Aspen Homes

Hickory GR Walk-Out Lot 91 HF
2022 SW Harvest Moon Ln.
Lee's Summit, MO

Our firm has been asked to make structural clarifications to the plans of the house to be built at the address listed above. During the permit review process the AHJ has questioned items. Below is a list of our recommendations along with the corresponding city item.

STRUCTURAL REVIEW
HD ENGINEERING & DESIGN
HD: 43036 DATE: 5/9/2022

S-0.1

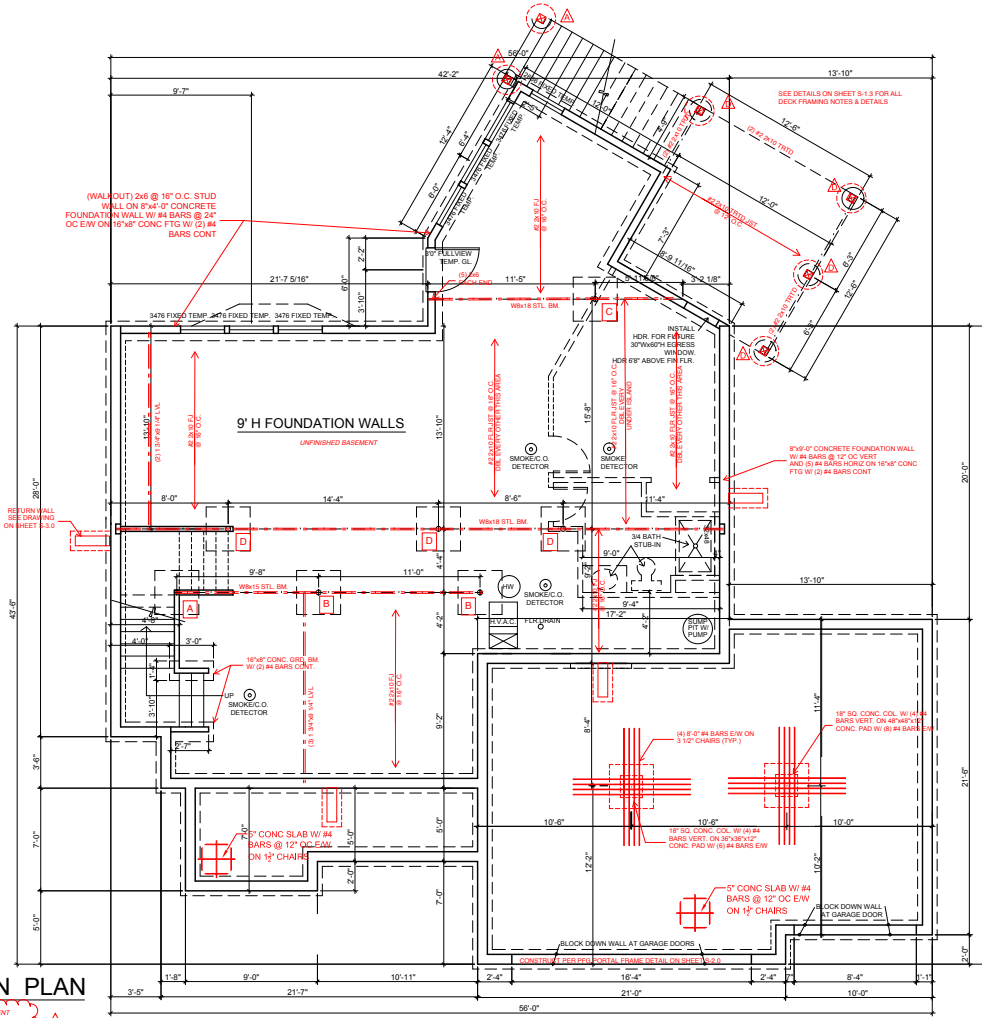
- The unfinished basement square footage is incorrect. It should be close to matching the 1st Floor square footage. Should be close to 1383.
See revised Sheet S-0.2 with clouded square footage.
- Need to remove the "Optional Back Elevation" from Sheet S-0.1
See revised Sheet S-0.1 with clouded elevation removal.
- Need to remove the Options plan sheet completely. Sheet S-0.4
See revised Sheets with previous Sheet S-0.4 removed.
